CITY OF ALBUQUERQUE

Re: Venice Volleyball Court
5801 Venice Ave. NE
Request for Certificate of Occupancy
Transportation Development Final Inspection
Architect's Stamp dated 02-26-24 (B18-D022)
Certification dated 02-28-25

Based upon the information provided in your submittal received 03-07-25, Transportation Development cannot approve the release of Certificate of Occupancy for the above referenced project.

TCL-1

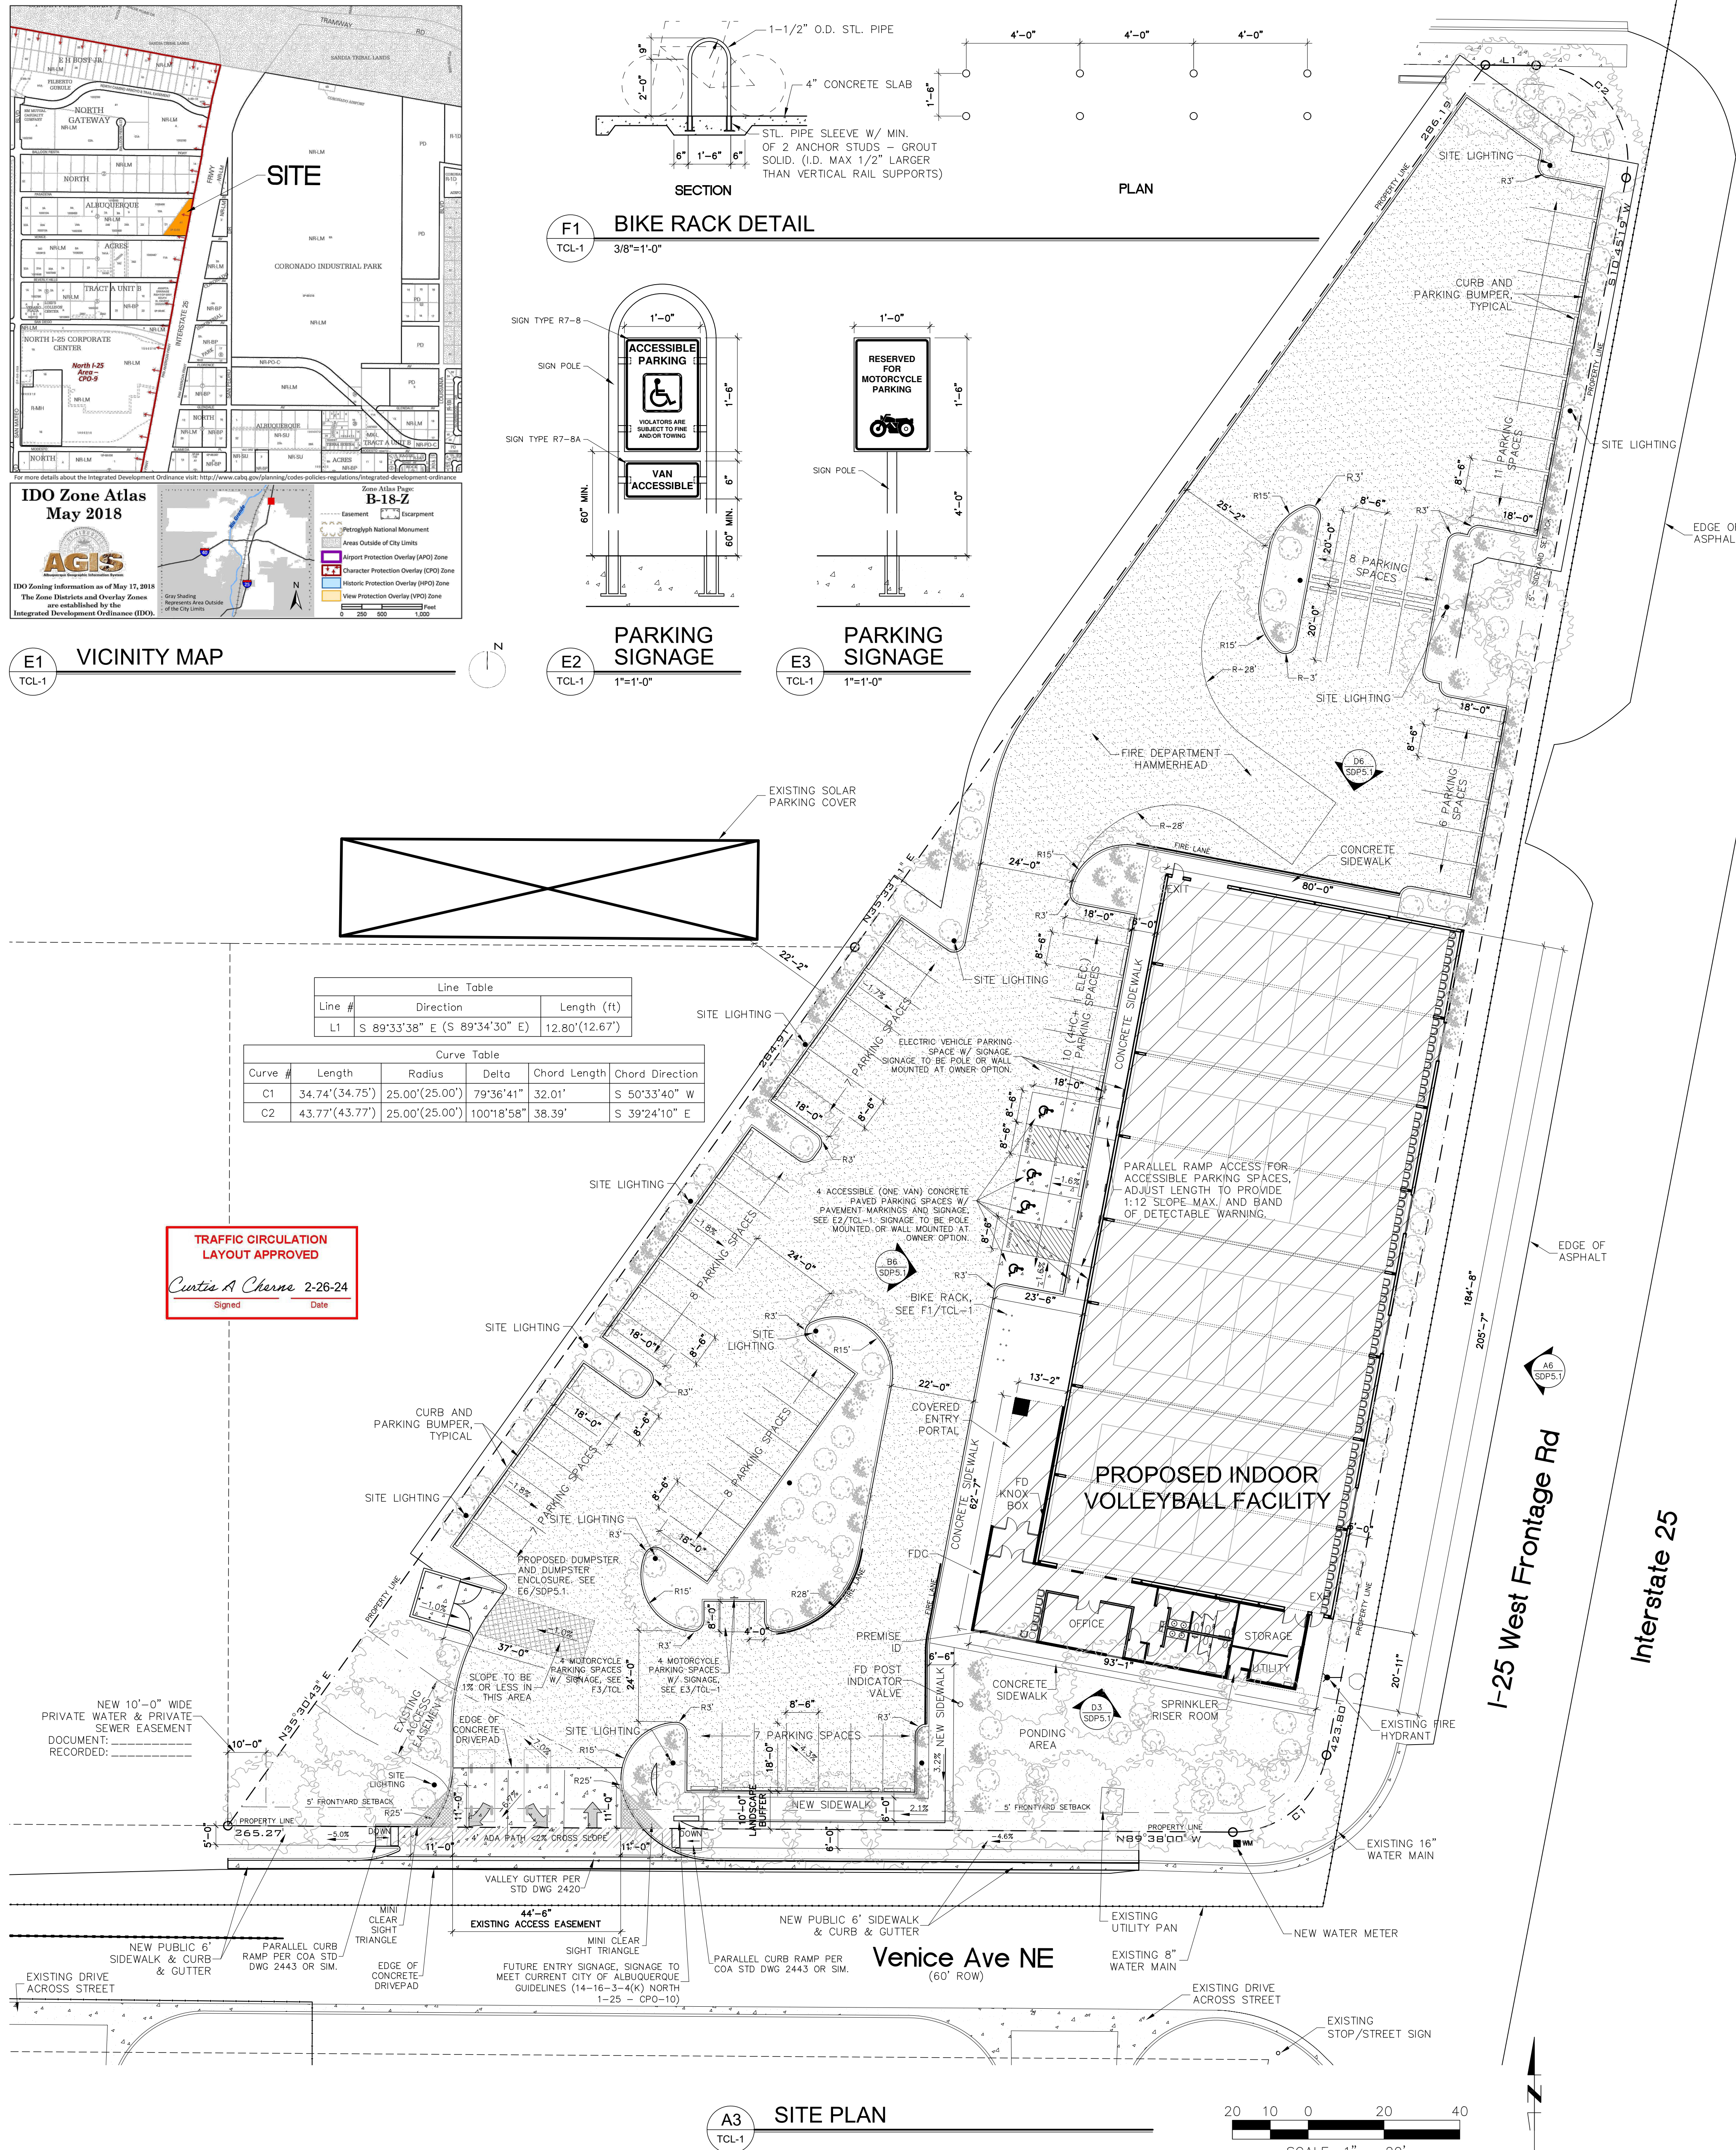
1. The Traffic certification letter must be stamped, signed, and dated by an engineer or architect licensed in the state of New Mexico using the standard language. See attached.
2. The north side parking lot must be constructed.
3. The east side of the site curb and parking bumper must be constructed.
4. The ADA pathway from the public sidewalk to the building entrance must be constructed.

1. The ADA accessible parking sign must have the required language per 66-7-352.4C NMSA 1978 **"Violators Are Subject to a Fine and/or Towing."** Please call out detail and location of signs.
2. The ADA access aisles shall have the words **"NO PARKING"** in capital letters, each of which shall be at least one foot high and at least two inches wide, placed at the rear of the parking space so as to be close to where an adjacent vehicle's rear tire would be placed. (66-1-4.1.B NMSA 1978).
3. During my site visit, I observed a lip in the concrete in the transition from the ADA aisle the ADA pathway. This uneven surface creates a tripping hazard. Please grind the area (the highlighted area) to ensure ADA compliance and smooth transition. Also, the parking bumper is missing in the ADA parking spaces.

4. Per approved site plan the public sidewalk width should be 6 ft. However, per the site visit it was only 5 ft. wide. Please ensure the sidewalk is constructed to the required 6 ft width as per approved site plan.
5. Please provide the direction arrows at the site access as shown in the site plan.
6. Anchor down Bike Rack.
7. Sidewalk culvert at the west side of the site access is missing.
